MEMORANDUM

Reference: DA20/0208
 To: Penrith Local Planning Panel
 From: Wendy Connell – Senior Development Assessment Planner
 Date: 24 November 2020
 Subject: Proposed Construction of Log Cabin Development – 20 Memorial Avenue & 712 High Street, Penrith

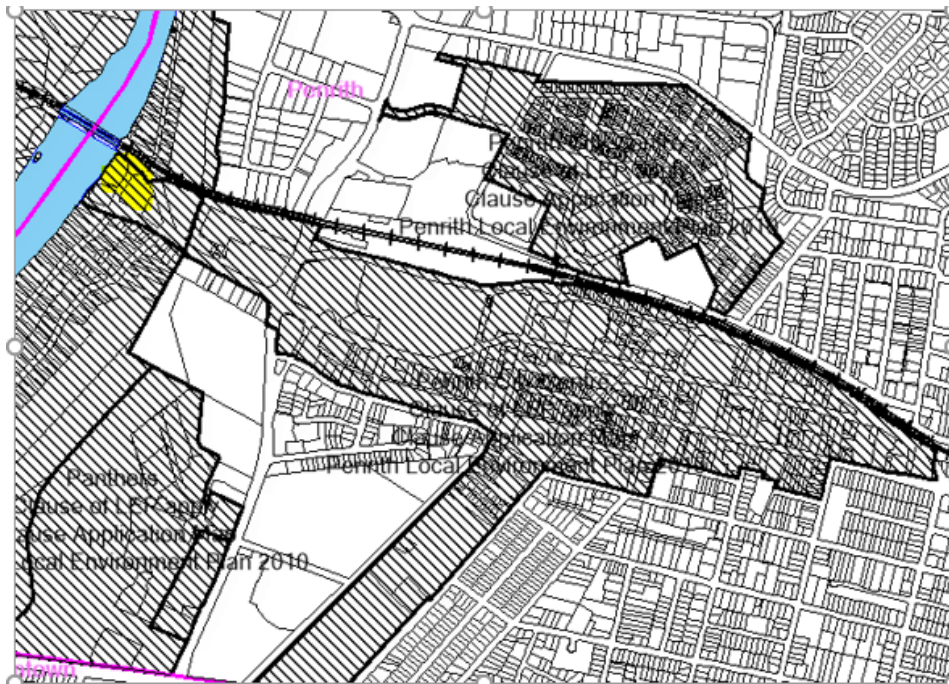
I refer to the subject development proposal and the related development assessment report that is scheduled for consideration by the Penrith Local Planning Panel on 25 November 2020.

This memorandum provides further information regarding the proposal and recommended consent conditions in response to several queries from the Panel.
